APPLICATION NO.	FILING DATE	FIRST NAMED INVENTOR	ATTORNEY DOCKET NO.	CONFIRMATION NO.
10/632,154	07/30/2003	Yi Ding	M-15230 US	1878
7590	07/08/2005		EXAMINER	
Michael Shenker			NGUYEN, KHIEM D	
MacPHERSON KWOK CHEN & HEID LLP				
Suite 226			ART UNIT	PAPER NUMBER
1762 Technology Drive			2823	
San Jose, CA 95110

Office Action Summary	Application No.	Applicant(s)
	10/632,154 Khiem D. Nguyen	DING, YI Art Unit 2823

DETAILED ACTION

Claims 1-17 and 30-38 are rejected under 35 U.S.C. 102(e) as being anticipated by Fang (U.S. Patent 6,667,511).

FIGURE 5c

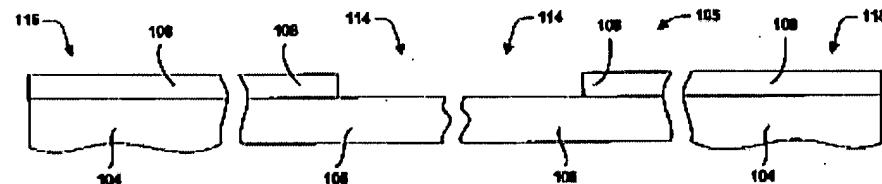
(a) forming a dielectric layer 108 on a semiconductor substrate 104, the dielectric layer comprising a first dielectric region 108 ("select gate dielectric") and a second dielectric region 162 ("first peripheral transistor gate dielectric"), wherein the select gate dielectric 108 and the first peripheral transistor gate dielectric 162 are formed simultaneously (col. 6, lines 10-20 and FIGS. 5c-d);

FIGURE 5l

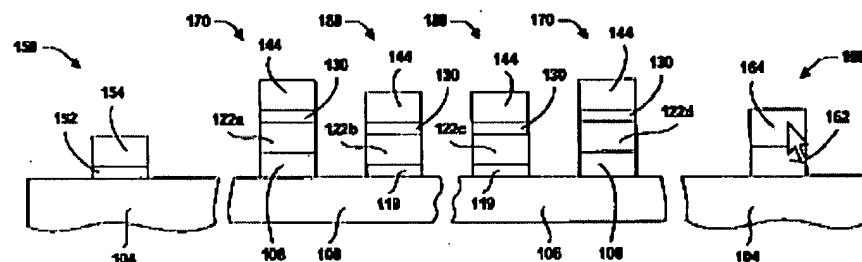
(b) forming a first layer 122 over the dielectric layer and patterning the first layer to provide (i) the select gate on the select gate dielectric 108, and (ii) a gate 164 for the first peripheral transistor 160 on the first peripheral transistor gate dielectric 162 (col. 6, lines 21-45, col. 7, lines 50-62 and FIG. 5l);

(c) after forming the first layer 122, forming one or more second layers 144 which provide the floating gates 122b, 122c and the control gates 144 for the memory cell 180, the floating and control gates being provided entirely by the one or more second layers, the floating 122b, 122c and control gates 144 comprising no portion of the first layer 122 (col. 7, lines 31-60 and FIG. 5l).

In re claim 2, Fang discloses that the memory cell comprises a continuous channel region 106 in the semiconductor substrate 104, the select gate 122a controls a conductivity of a portion of the channel region 106, and each of the floating gates 122b, 122c overlies a respective other portion of the channel region 106 (col. 6, lines 2-20 and FIG. 5l).

In re claim 3, Fang discloses that the control gates 144 overlie the respective floating gates 122b, 122c (FIG. 5l).

In re claim 4, Fang discloses that the one or more second layers 144 are a plurality of layers (FIG. 5l).

In re claim 5, Fang discloses that the select gate dielectric 108 and the first peripheral transistor gate dielectric 162 are formed by oxidation of the semiconductor substrate 104 (FIG. 5l).

In re claim 7, Fang discloses that the method of Claim 1 further comprising, after forming the first layer **122**, forming a dielectric **130** (“floating gate dielectric”) on the semiconductor substrate **104** to separate the floating gates **122b, 122c** from the substrate **104**, wherein the floating gate dielectric **130** is formed of the same material as the select gate dielectric **108** but is thinner than the select gate dielectric **108** (col. 6, line 63 to col. 7, line 2 and FIG. 5l).

In re claim 8, Fang discloses that the method of Claim 1 further comprising forming a second peripheral transistor gate dielectric **152** on the semiconductor substrate **104** for a second peripheral transistor **150**, and forming a gate **154** of the second peripheral transistor on the second peripheral transistor gate dielectric **152**, wherein the second peripheral transistor gate dielectric **152** is made from the same material as the select gate dielectric **108** and the first peripheral transistor gate dielectric **162** but the thickness of the second peripheral transistor gate dielectric **152** is different from the thickness of the first peripheral transistor gate dielectric **162** (col. 7, lines 31-60 and FIG. 5l).

In re claim 9, Fang discloses that the second peripheral transistor gate dielectric **152** is thinner than the first peripheral transistor gate dielectric **162** (FIG. 5l).

In re claim 10, Fang discloses that the select gate dielectric **108** as at least as thick as a gate dielectric **162** of any peripheral transistor **150, 160** in the memory (FIG. 5l).

In re claim 14, Fang discloses that the memory cell 180 is one of a plurality of nonvolatile memory cells of the memory, each memory cell comprising two floating gates 122b, 122c, a select gate 122a, and two control gates 144, wherein: the operation (a) simultaneously forms select gate dielectric 108 for each of the memory cells; and the operation (b) simultaneously forms the select gate 122a for each of the memory cells on the corresponding select gate dielectric (col. 7, lines 19-60 and FIG. 5l).

In re claim 17, Fang discloses that the memory is to support a writing operation in which the memory cell is written by a transfer of a charge between one of the floating gates 122b, 122c and a channel region 106 of the memory cell, the channel region being located in the semiconductor substrate 104 (FIG. 5l).

FIGURE 5c

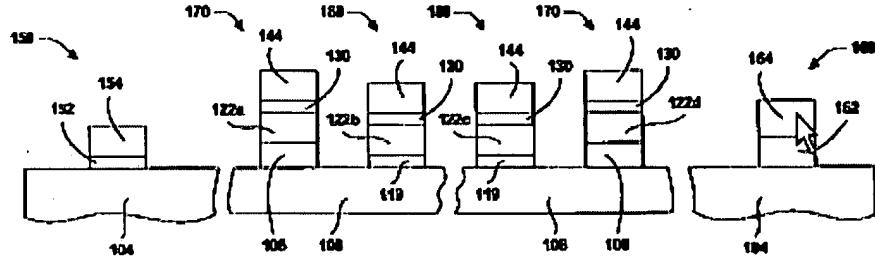
In re claim 30, Fang discloses that the operation (c) further comprises patterning the one or more second layers 144 to provide the floating 122b, 122c and control gates 144 (col. 7, lines 31-60 and FIGS. 5a-l).

In re claim 31, Fang discloses that the first layer patterning comprises:
(b1) patterning the first layer 122 to provide the select gate 122a; and
(b2) patterning the first layer 122 to provide the gate 164 for the first peripheral transistor 160;

wherein the operation (c) is performed after the operation (b1) but before the operation (b2) (FIGS. 5a-l).

FIGURE 5^c

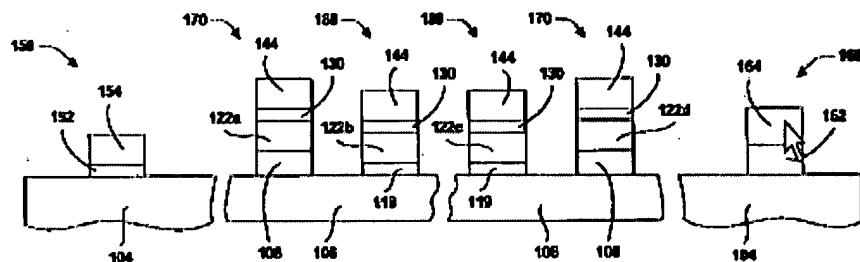
In re claim 34, Fang discloses that the memory cell 180 comprises a continuous channel region 106 in the semiconductor substrate 104, and each of the floating gates 122b, 122c controls a conductivity of a respective portion of the channel region 106 (FIGS. 5a-l).

In re claim 35, Fang discloses that the select gate controls 144 the conductivity of a portion of the channel region 106 (FIGS. 5a-l).

In re claim 36, Fang discloses that the channel's portion 106 whose conductivity is controlled by the select gate 122a is between the channel's portions 106 whose conductivities are controlled by the floating gates 122b, 122c (FIGS. 5a-l).
